SIB 65 18 24

RECALL 24V-513: Check Drivers Air Bag (Conversion PSDI-5)

This Service Information Bulletin (Revision #2) replaces SI B65 18 24 **dated August 2024**.

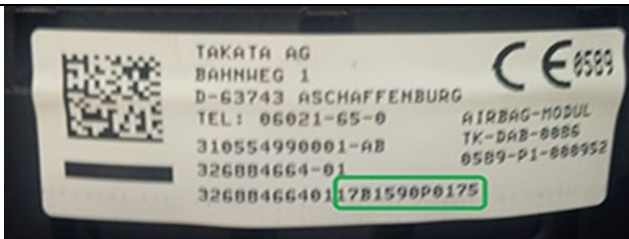
B- Here are pictures of the recalled Sport Steering wheels to use for visual identification. If you have one of the following air bags installed it must be brought into the BMW dealer for inspection and possible replacement:

This is an E83 Sport air bag and may have been swapped into different vehicles.

If one of the above Sport steering wheels is installed, then:

1-Please record exterior cosmetic condition of air bag/steering wheel assembly on the Repair Order prior to any repair. Take pictures of any existing cosmetic damage.

2-Remove air bag to check parts label. Unless the air bag is either part number 6884664 or 6884672 (E8x, E9x) **OR** 6884661 or 6884669 (E83) then it must be replaced as per **REP 32 34 030** - Removing and installing/ replacing air bag unit (sport steering wheel)
